System Impact Assessment Report

**Gosfield
Wind Generation Station (WGS)**

Final Report

CAA ID 2002-078

Figure 1: Setting for Grid Under-frequency Trip Protection

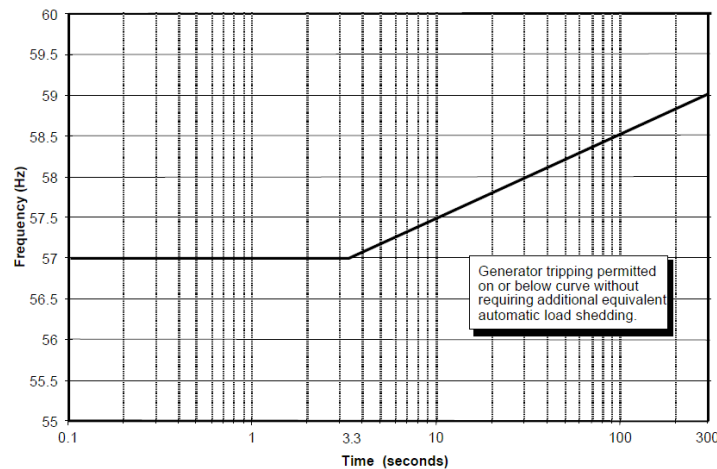
- (8) The generators should not trip for frequency variations that are above the curve in Figure 1.
 - (9) The applicant is responsible for providing real-time telemetering of the following variables to the IESO:

The facility must be capable of operating at full active power for a limited period of time for grid frequencies as low as 58.8 Hz. Generators must not trip for under-frequency system conditions that are below 60 Hz but above 57.0 Hz and above the curve shown in Figure 1.

Figure 4: Terminal Voltage of Wind Generator During 3-phase fault at Lauzon TS

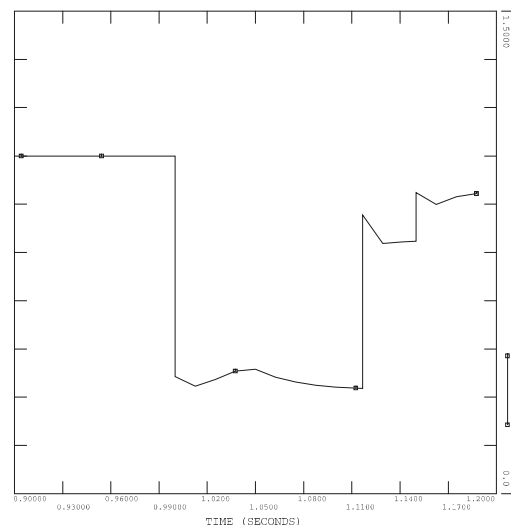
In order to examine the need for LVRT capability, the three phase fault on K6Z at Lauzon with normal clearing time was simulated. This particular contingency is electrically much closer to the new generation facility than other contingencies. Thus, it could potentially have a greater impact on the terminal voltage of the facility. The variation of the terminal voltage of the new generation facility is plotted in Figure 4 below. It can be seen that the duration during which the generator terminal voltage drops below 0.5 pu is about 0.11 sec. Therefore, fault ride through capability of the wind turbines is adequate.

The LVRT capability must be demonstrated during commissioning by monitoring several variables under a set of IESO specified field tests and the result should be verifiable using the PSS/E model.
